1.0 Introduction

- 1.1 This Technical Note provides a response to the comments made by Leicestershire County Council as Lead Local Flood Authority (LLFA) in their consultation response dated 21st November 2024 to planning application reference 24/00484/OUT. A copy of the response is enclosed in **Appendix A**.

Application address Land East of Leicester Road Earl Shilton Leicestershire		Planning ref.	24/00484/OUT
		Our ref.	2024/0484/04/F
Description Outline planning application (some matters reserved except for means of access and scale) for the erection of up to 33 dwellings, including affordable housing, public open space, landscape planting, sustainable drainage system and new access arrangements from the Un-named Road		Consultation date	04/11/2024
		Response date	21/11/2024
Planning officer	Sullivan Archer	Reviewing officer	Jess Nobbs
Application type	Outline	Extension requested	☐
Refer to standing advice ☐	Conditions ☐	Further consultation required ☒	Concerns ☐

Figure 2.1: Extract from Topographical Survey

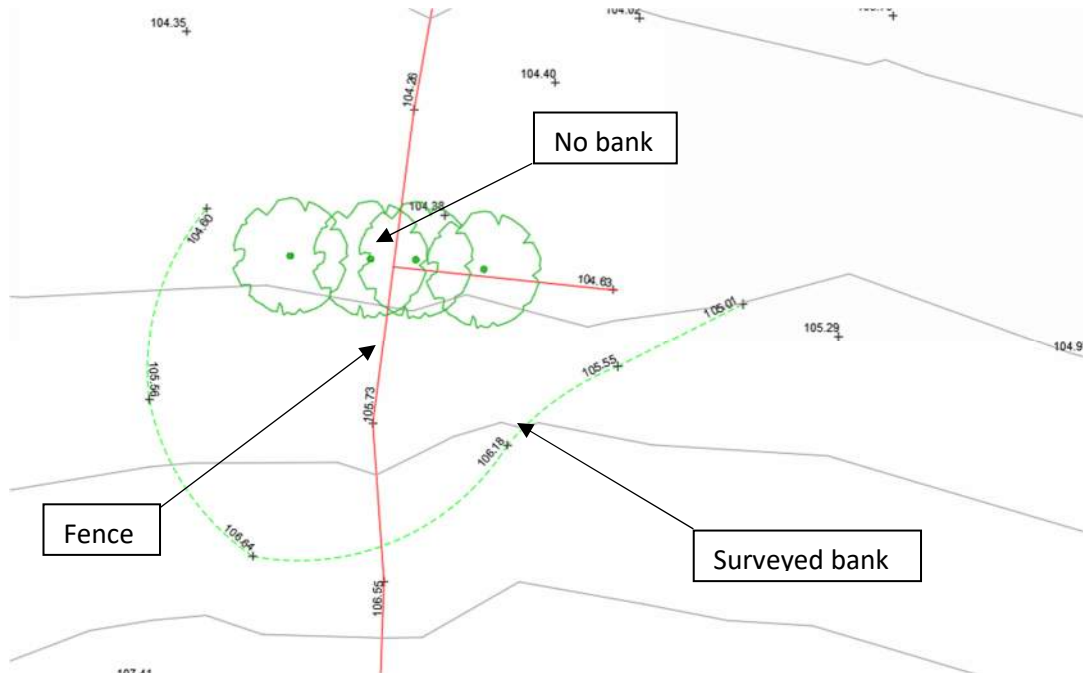
The existing details show an on-site pond with no apparent way of intercepting water. This pond is not discussed in the Flood Risk Assessment. With the adjacent road named 'Spring Gardens', there is concern that this pond is fed by a spring, and the removal of this pond possibly resulting in spring water creating a risk to development. It needs to be demonstrated that this feature does not pose a risk to the development and where this is deemed to be a spring, water is safely routed.

- 2.1 The references to pond on the OS map are incorrect, there is no pond in this location.
- 2.2 The area marked “pond” on the OS map can be seen on the topographical survey extract at **Figure 2.1** below with the full survey in **Appendix B**. There is a surveyed ridge (green dashed line) to three sides but nothing to the north. The surveyed levels do not indicate any depression here either.

- 2.3 A site visit has confirmed that there is no pond in this location as shown in the photograph of the area at **Figure 2.2**. Therefore, whilst there might be a slight localised depression here, if there is it is minimal and as the topographical survey of the “pond” shows this area is unable to store any water.

Figure 4.2: Route of outfall to watercourse

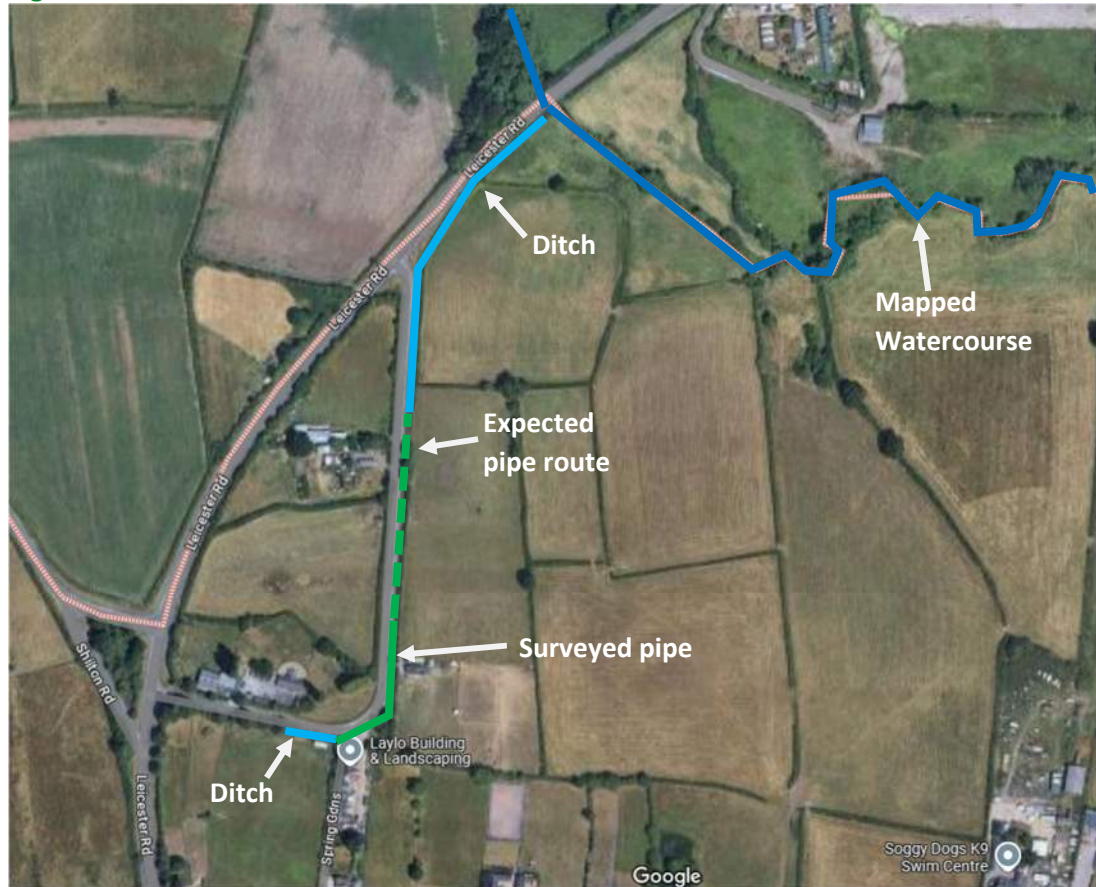
The CCTV survey is inconclusive, and it is still unclear where the ditch along the northern boundary is routed. The applicant should attempt further work and/or desk study to clarify the surface water flow route off-site.

- 4.5 The indicative route of the outfall is shown in **Figure 4.2** below. As this shows, the pipe travels for approximately 38m towards the hedge line located on the eastern side of the unnamed road, at which point the pipe turns northwards and travels along the route of what is presumably a now piped ditch with an approximate depth of 1.4m.

- 4.6 The pipe was clear with some minor root ingress but otherwise in good condition and at all times was running clear with no standing water which indicates that this is the case all the way to the outfall. If it was not and the outfall was blocked the pipe would be full in no time with the incoming flow.

- 4.7 The survey of the drainage outfall was able to cover some 90m from the manhole, which was the limit of the survey due to technical constraints comprising upstream access only, a small diameter pipe, the turn to follow the ditch line and no other access points being provided.
